ATR on Quality Control Check Report (Bungalows)

Bungalow No	20	QC report stage	I	Sl. No.	27972
Company	Milini Estak	Project	ME	Phase	
Prepared by	K. Suresh Babu	Sign	Suresh Babu	Date	16/09/2017
Project Manager	Radheshyam	Sign	Radheshyam	Date	16/09/2017
Receipt by QC date		Sign		Other	
Receipt at HO date		Sign		Other	
Checked By MD on		MID Sign		For filling	<input type="checkbox"/> Yes <input type="checkbox"/> No

Quality Control Check Report. Stage: After Plumbing & Electrical (Villas)

Bungalow no.	20	Stage	-	SL No.	27972
Company	Milgiri estate	Project	Milgiri estate	Phase	II
Prepared by	M. G. Sridhar	Sign	[Signature]	Date	11/09/17
Project Manager	Ratheshyam	Sign	[Signature]	Date	11/09/17
Previous stage report no.	27772	Report filed and signed by PM?		<input checked="" type="checkbox"/> Yes	<input type="checkbox"/> No
Additions & alterations sheet date	14/05/16	All pages signed by engineer & customer?		<input checked="" type="checkbox"/> Yes	<input type="checkbox"/> No
Checked By MD on	MD Sign	For filling		<input type="checkbox"/> Yes	<input type="checkbox"/> No

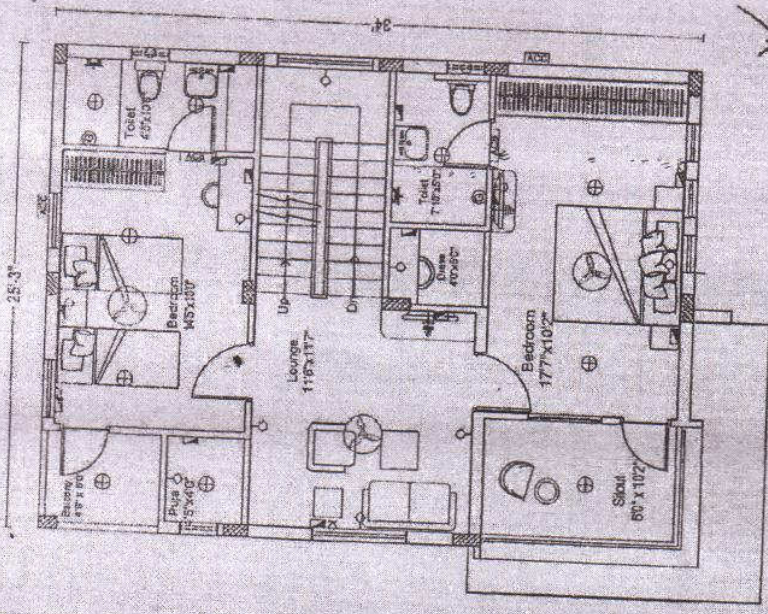
S No	Room	Civil work near pipes in balcony & utility (✓ or X)	CPVC & PVC Check (✓ or X)	Electrical points check (✓ or X)	Water proofing check (✓ or X)	Proper use of fasteners check (✓ or X)	Placement of DB (✓ or X)	Placement of Generator changeover (✓ or X)
1	Bedroom 1 (MB)	-	-	✓	-	-	-	-
2	Toilet 1 (MT)	-	✓	✓	-	-	-	-
3	Bedroom 2 (MT) 1st	-	-	✓	-	-	-	-
4	Toilet 2 (MT) 1st	-	✓	✓	-	-	-	-
5	Bedroom 3 (CB) 1st	-	-	✓	-	-	-	-
6	Toilet 3 (KT) 1st	-	✓	✓	-	-	-	-
7	Bedroom-4	-	-	-	-	-	-	-
8	Toilet-4	-	-	-	-	-	-	-
9	Drawing	-	-	✓	-	-	✓	-
10	Dining	-	-	✓	-	-	-	-
11	Lobby-1 Drawingist	-	-	✓	-	-	-	-
12	Lobby-2	-	-	-	-	-	-	-
13	Terrace/balcony-1	-	-	-	-	-	-	-
14	Terrace/balcony-2	-	-	-	-	-	-	-
15	Head-room	-	-	-	-	-	-	-
16	Portico	-	-	-	-	-	-	-
17	Kitchen	-	-	-	-	-	-	-
18	Utility	✓	✓	-	-	-	-	-
19	Other	-	-	-	-	-	-	-
Remarks	<p>1. Pipes highly in Villa was not as per Specification Note: There was some Customer Change</p>

Remarks:	<p>① Plot top to print changed height done.</p> <p>② lower Area leveling and soil back leveling done.</p>
